MEMORANDUM

PROJECT: Travilah Road Phase I
From Darnestown Road (MD28) to Dufief Mill Road
CIP Project No. 500101

REVIEW TYPE: Preliminary/Final Water Quality Plan Approval (Piney Branch
Special Protection Area) and Mandatory Referral No. 01812-
DPW&T-1

Re: **Preliminary/Final Water Quality Plan and
Stormwater Management Concept for Travilah
Road Improvements**
SM File #: 205541
Montg. Co. Page: 27&28
Watershed: Watts Branch/Piney Branch

TYPICAL ROAD SECTION

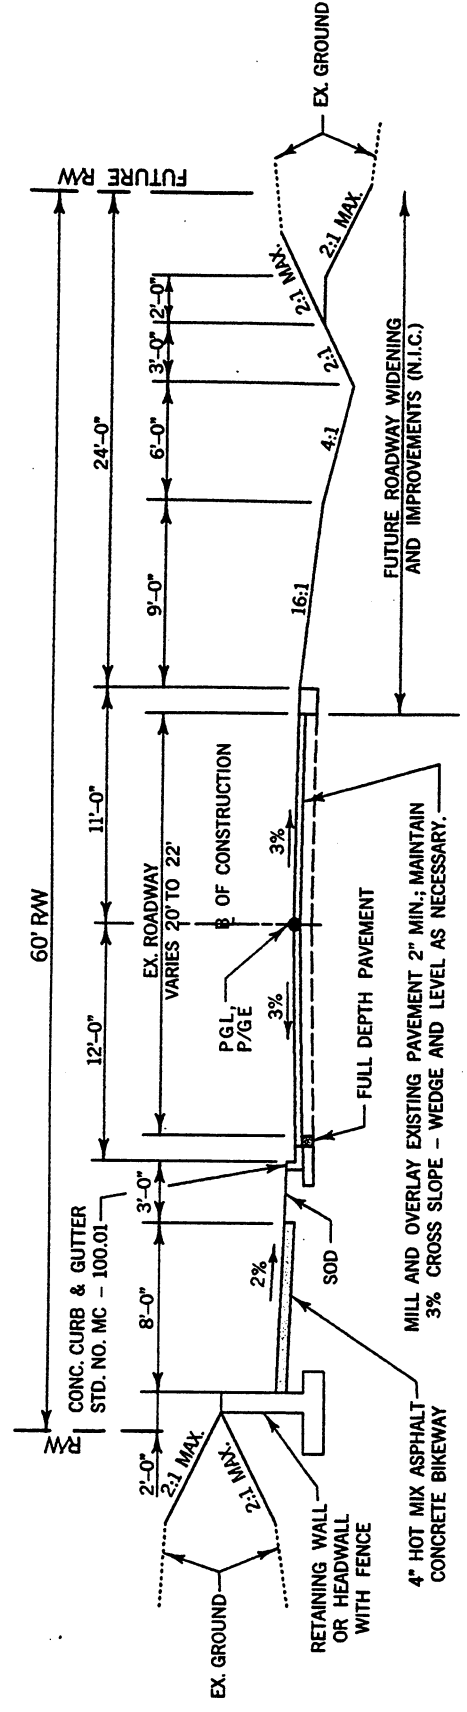
While most of the roadway is open-section, one 650-foot segment would be built with a curb where a large culvert under the roadway and a home close to the roadway exist as constraints to the typical treatment. The offset from the proposed hiker-biker trail to the curb would be three feet in this area (see Attachment 3).
